ORDINANCE 99-06

TO AMEND THE PRELIMINARY PLAN FOR THE BELLE TRACE
PLANNED UNIT DEVELOPMENT
Re: 3630 East 10th Street
(CarDon & Associates, Petitioner)

CASE NO: PUD-77-98
DATE: February 1, 1999

Re: Bell Trace Retirement Community
Preliminary Plan Amendments - Revised Statement

PUD-77-98,
Proposed Bldg. Expansion +
Garage/Carports

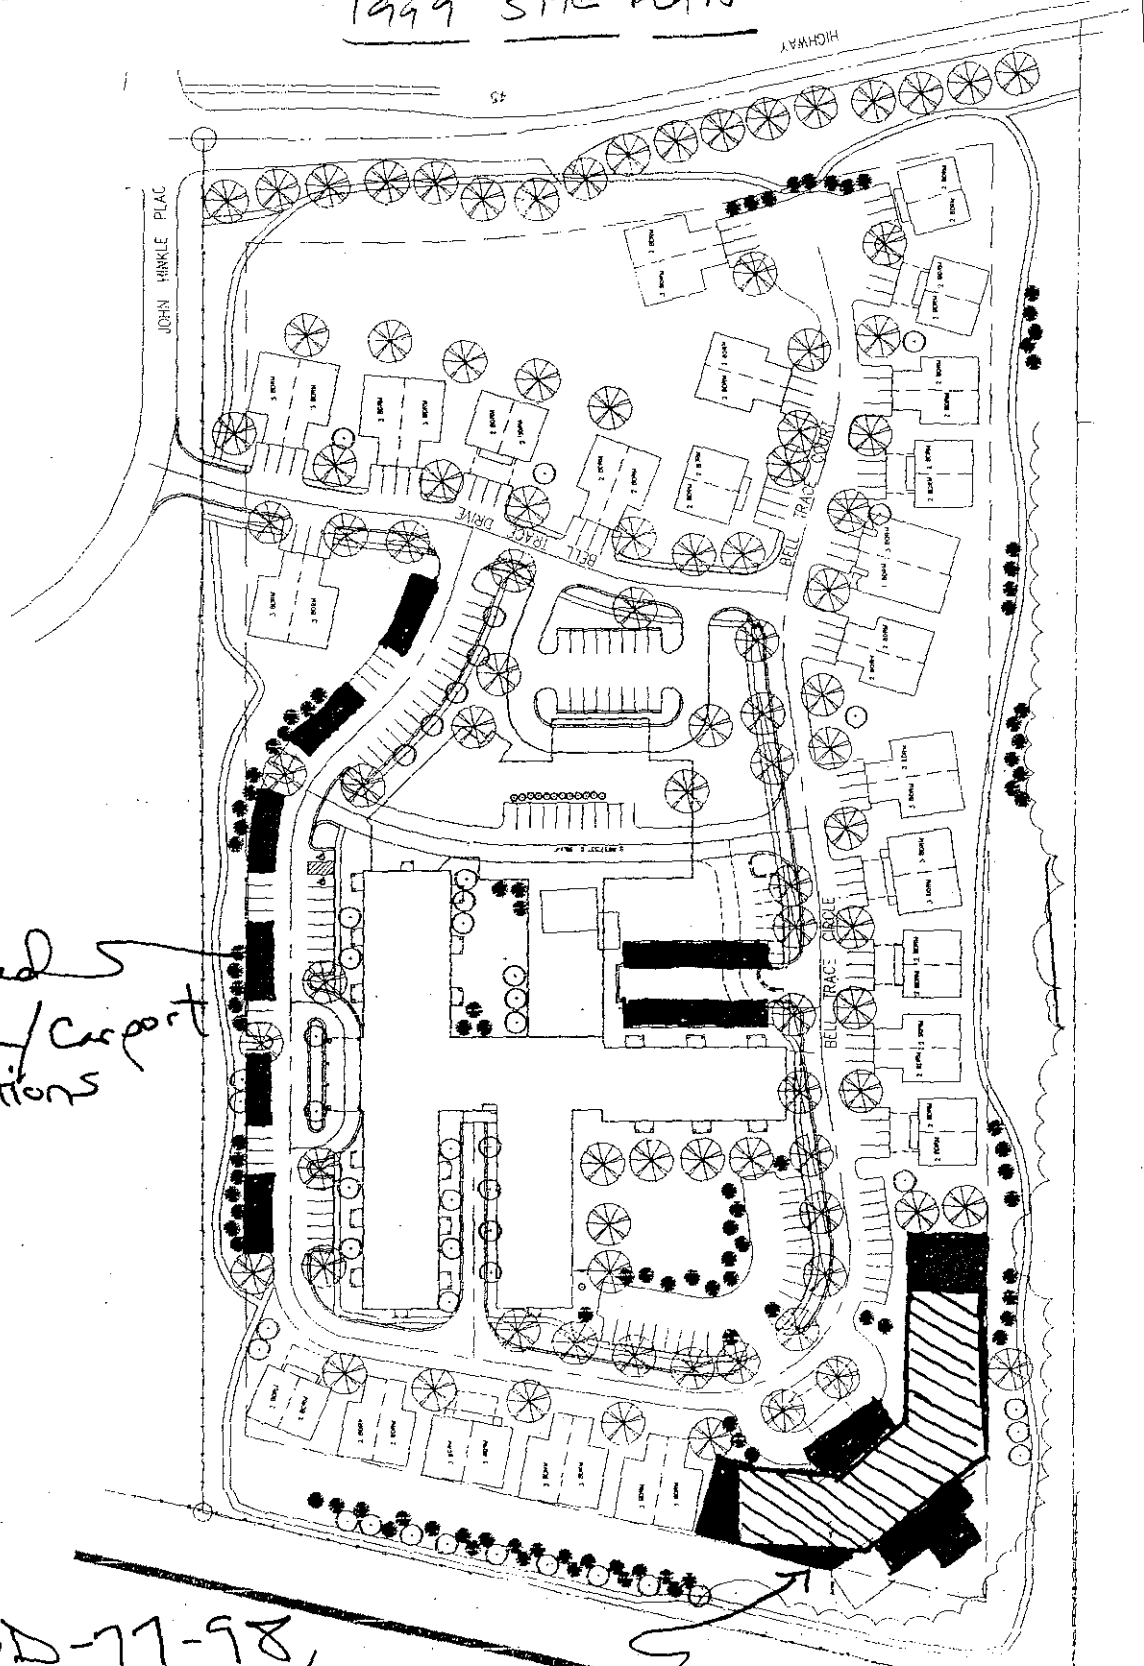
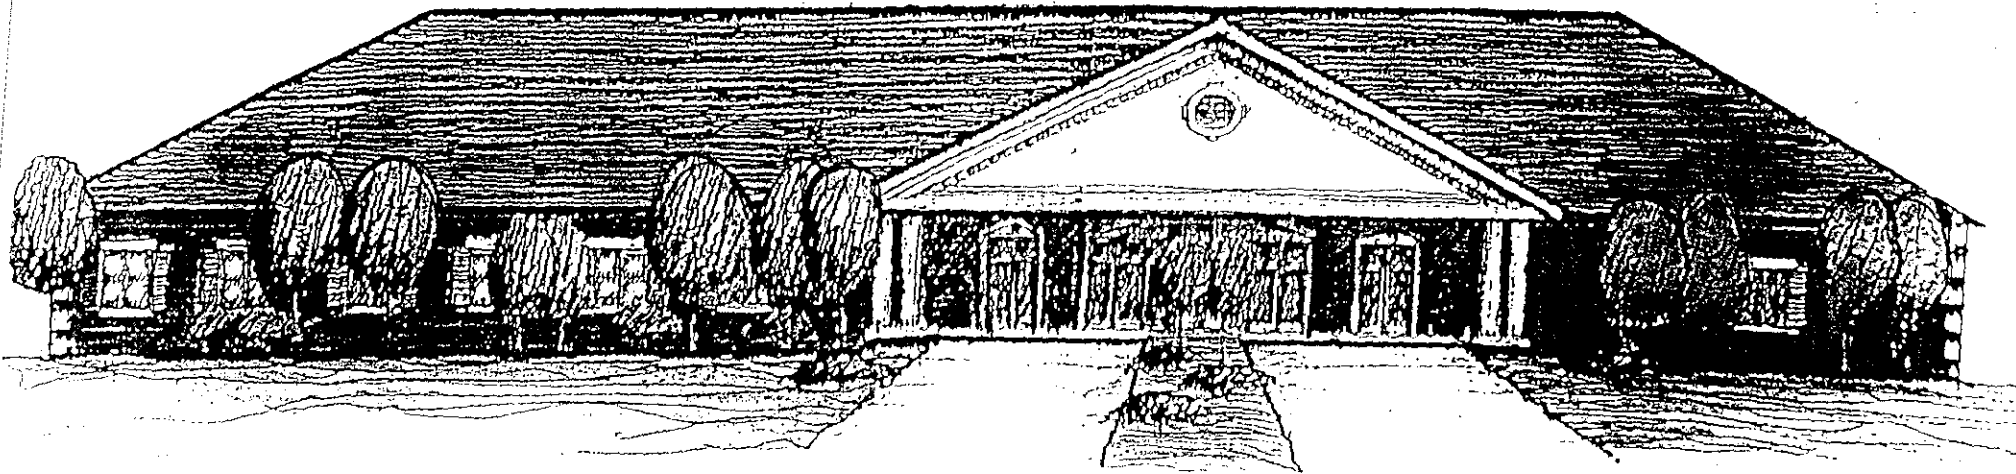
REPORT SUMMARY: The first request is for the enlargement of the nursing home facility. PUD regulations require a major plan amendment when the cube of building increases more than 20%. The petitioner was granted approval to place the nursing home facility in the southeast corner of the site in the 1997 approval. The facility was approved as a 16,800 square foot, one story building. The requested expansion of the proposed single story building to 22,000 square feet is a 24% increase in the cube of the building. Since the initial hearing the proposed location of the building has been moved out of the 60 foot required setback, and will not require the removal of additional trees. The expansion is needed to allow more single bed private rooms for the patients. Staff is supportive of this building enlargement for better patient care.

The second petition request is for the creation of 58 covered parking spaces. These parking spaces currently exist on the site. Many of the residents will have cars. To assist these people in keeping their cars free of ice and snow, the petitioner is requesting carports and garages for some of the parking spaces. This request does not impact open space, and tree preservation is not an issue. The carports and garages are proposed to be brick with shingled roofs. Staff is supportive of the use of carports and garages.

During the course of the neighborhood meeting and the preliminary Plan Commission hearing on January 11, 1999, two concerns were brought forth. The first is the lack of tree buffer in the vicinity of the eastern detention area. The

petitioner has agreed to place a minimum of seven hardwood deciduous trees and five evergreen trees in this area. Then once the cottages are constructed in that area, additional landscaping will be placed. The second concern was the exterior lighting plan for the complex. Instead of placing brighter security lighting on the main building, the petitioner has agreed to place pedestrian scale lighting on the interior streets of the development.

- 1) A tree buffer shall be placed along the east edge of the property in the area of the detention facility. A minimum of seven (two inch caliper) hardwood deciduous trees and five (6 foot tall) evergreen trees will be installed in the 1999 planting season.
- 2) Home style low wattage decorative lanterns shall be placed on the nursing home facility to insure a residential character to the building and a minimum of light pollution over the property lines.
- 3) Pedestrian scale street lighting shall be installed on the interior streets of the development. No additional halogen lamps will be placed on the main building.

Proposed covered parking shelters for
HELL TRACE RETIREMENT COMMUNITY
8430 East 10th St
Bloomington, Indiana

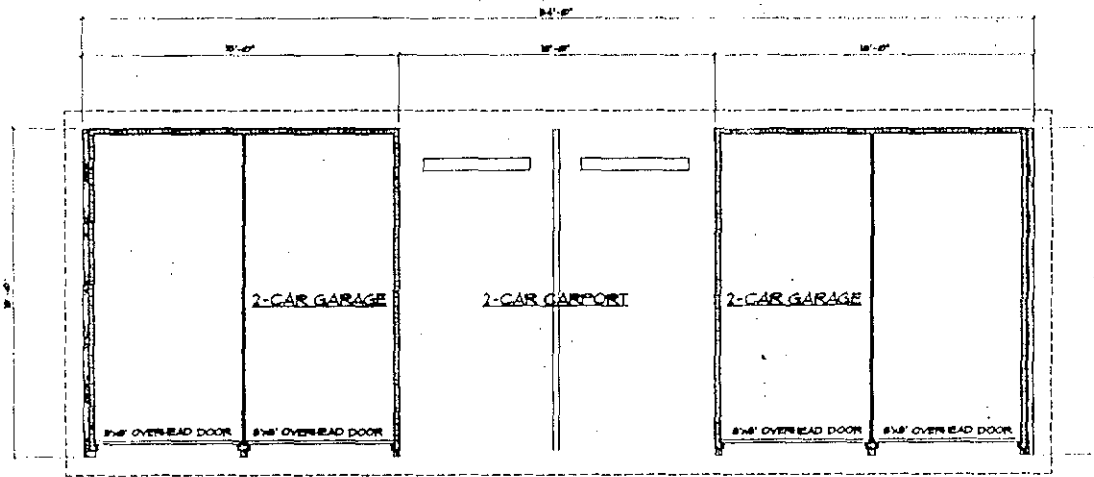
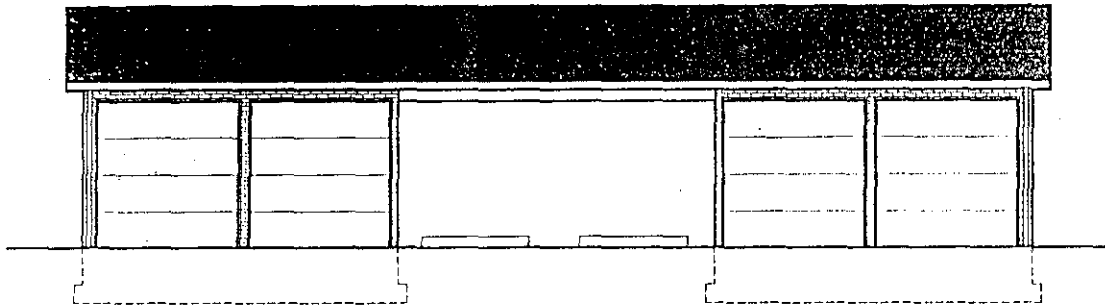
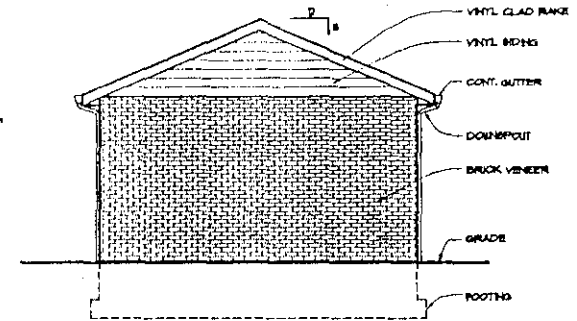
Additionally, a part of this request is the addition of covered parking structures in select areas on site. We are asking to build structures to cover 58 parking stalls along and adjacent to the central congregate building. (See attached plan for exact locations) These structures will consist of a steel and wood frame structural system supporting a 5/12 pitched shingled roof. Each structure will cover six spaces and have four garaged spaces and two carport spaces. The only exception are the covered spaces along the East end of the building, which will have a mixture of garages.

and carports. These structures will be placed over existing paved parking stalls, therefore not eliminating any existing or proposed green space.
